PG&E Letter DCL-03-109

Docket No. 50-323, OL-DPR-82  
Diablo Canyon Unit 2  
Supplemental Information to Support License Amendment Request 03-10, "Revised  
Steam Generator Voltage-based Repair Criteria Probability of Detection Method for  
Diablo Canyon Unit 2 Cycle 12"

**Supplemental Information on Characterization of Steam Generator Indications  
Regarding License Amendment Request 03-10, "Revised Steam Generator  
Voltage-based Repair Criteria Probability of Detection Method for  
Diablo Canyon Unit 2 Cycle 12"**

Response to NRC Questions Received on June 3, 2003

Figure 1

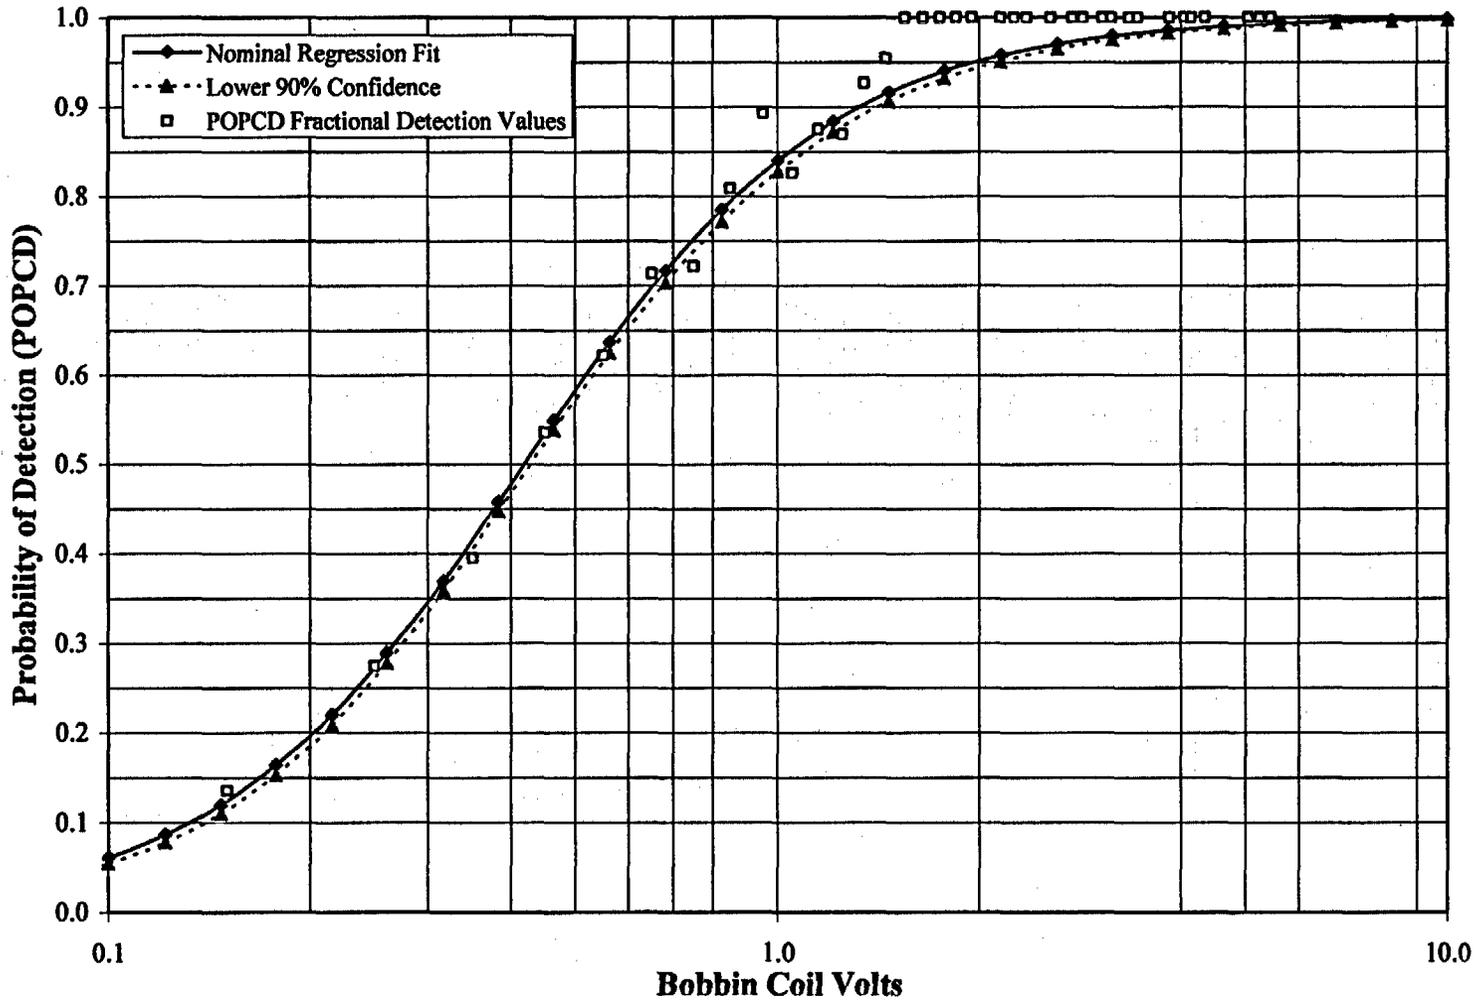
Figure 1 shows the loglogistic fit to the Table 1 Revised LAR POPCD data. The lower 90-percent confidence bound on the POPCD distribution and the fractional probability of detection (POD) data values are also shown for information. The fractional POD values are not used in the general linear model analyses since the POPCD analysis is weighted by the number of detected and undetected indications in each voltage bin. This figure replaces Figure 2 in DCL-03-078.

Therefore, PG&E recommends that Unit 2 Cycle 12 Monte Carlo analysis be based on the Revised LAR POPCD data in Table 1 and Figure 1. This recommendation is consistent with the requirements of GL 95-05, which requires that RPC NDD indications be included in the operational assessment as detected indications. Inclusion of the RPC NDD indications in the POPCD data as undetected bobbin indications would effectively further increase the number of RPC NDD indications in the operational assessment due to the decrease in POD for these indications.

Figure 2

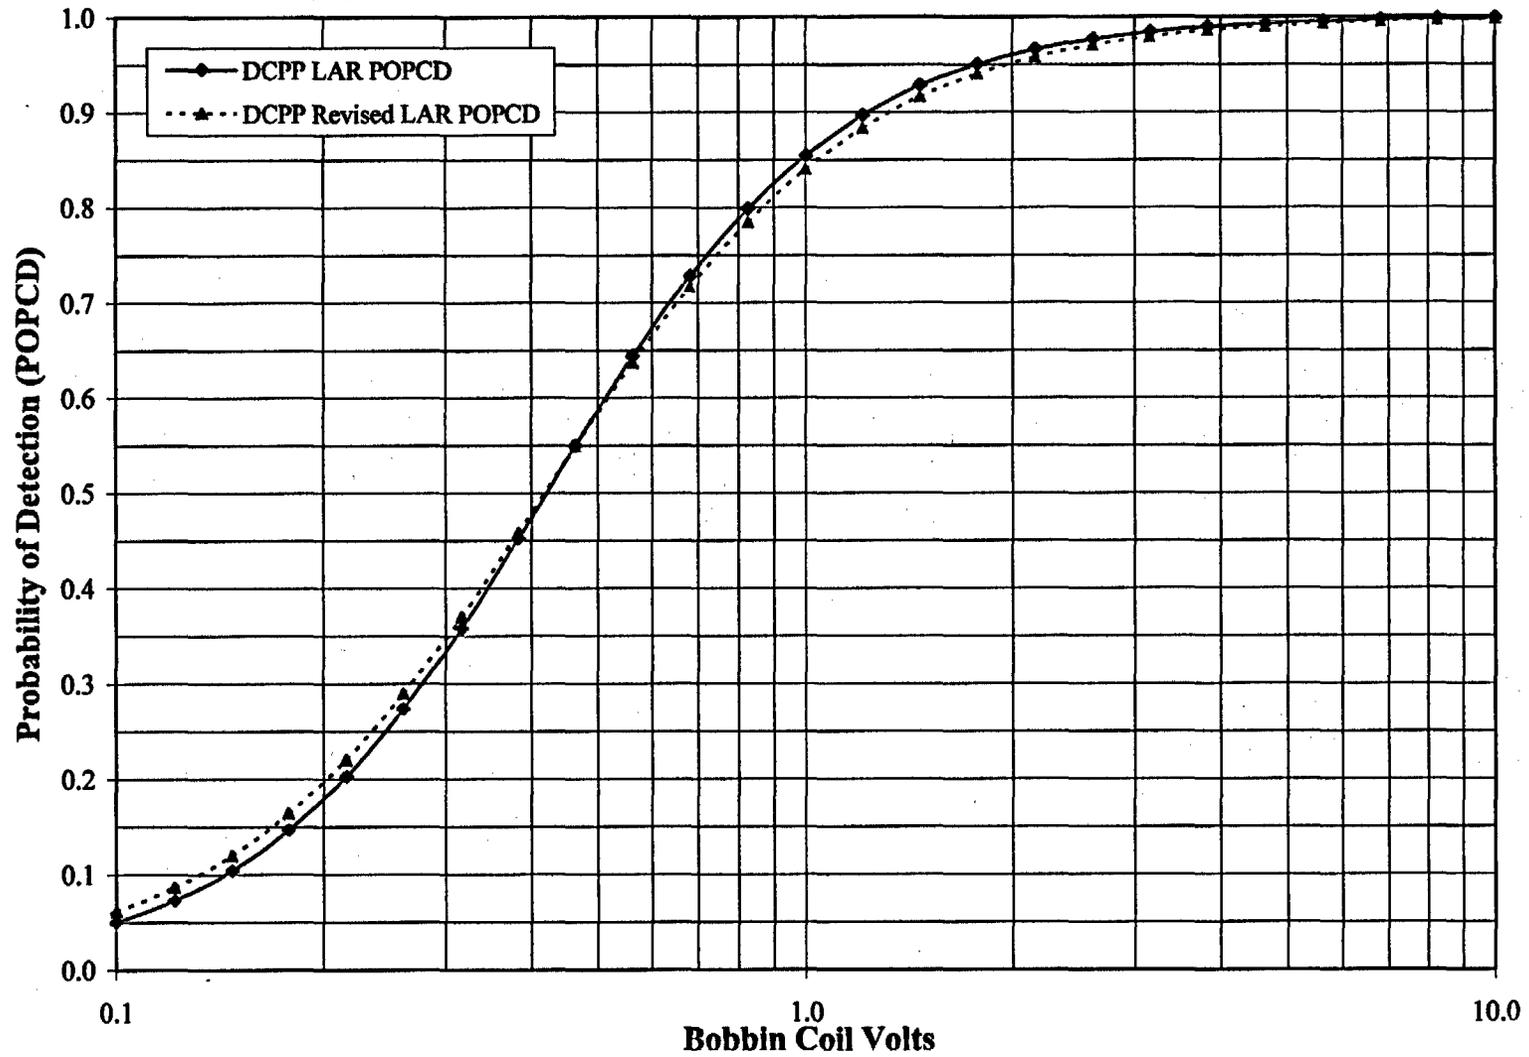
Figure 2 compares the loglogistic Revised LAR POPCD curve with the loglogistic LAR POPCD curve (from Figure 2 in DCL-03-078). Compared to the LAR POPCD data, the Revised LAR POPCD data decreases the POD above about 0.5 volt and increases the POD below about 0.5 volt.
